Access Compliance Report

Public Rights-of-Way

Intersection ID: 10035175	Main Street: QUAIL_HILL_RD	Cross Street: N/A	Location: E
ADA ID: 066E0082AC37	Ramp Type: Perp	Initial Pass/Fail: Fail	Overall Compliance: No
		Severity Score: 12.5

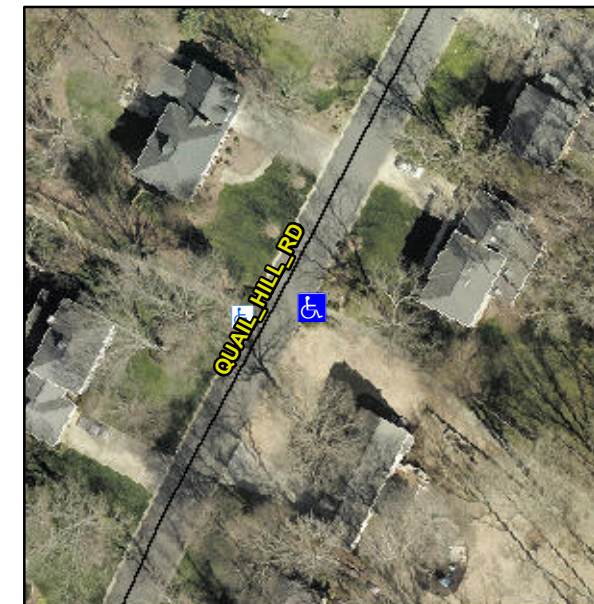
R304.2.2

Compliance	Description	Data	Compliance	Description	Data
N/A	Ramp Length (in)	48.0	No	Ramp Slope (%)	8.7
Yes	Ramp Width (in)	48.0	Yes	Ramp XSlope (%)	0.5
N/A	Flare Type LT	N/A	N/A	Flare Type RT	N/A
N/A	Flare Slope LT (%)	N/A	N/A	Flare Slope RT (%)	N/A
N/A	Flare Traversable LT?	N/A	N/A	Flare Traversable RT?	N/A
N/A	Landing Length (in)	N/A	N/A	DWS Provided?	N/A
N/A	Landing Width (in)	N/A	N/A	DWS Contrast?	N/A
N/A	Landing Slope (%)	N/A	N/A	DWS Length (in)	N/A
N/A	Landing X Slope (%)	N/A	N/A	DWS Full Width?	N/A
N/A	Landing Curb? (Y/N)	N/A	N/A	DWS Offset (in)	N/A
N/A	Shared Landing?	N/A			
N/A	Gutter Ponding?	N/A	N/A	Gutter Slope (%)	N/A
N/A	Gutter Lip Ht (in)	N/A	N/A	Gutter X Slope (%)	N/A
N/A	Painted X Walk1?	No	N/A	Painted X Walk2?	N/A
	X Walk 1 Direction	To W		X Walk 2 Direction	N/A
N/A	X Walk 1 Width (in)	N/A	N/A	X Walk 2 Width (in)	N/A
	X Walk 1 Slope (%)	2.3		X Walk 2 Slope (%)	N/A
	X Walk 1 X Slope (%)	0.5		X Walk 2 X Slope (%)	N/A

Remove & Replace Entire Ramp.
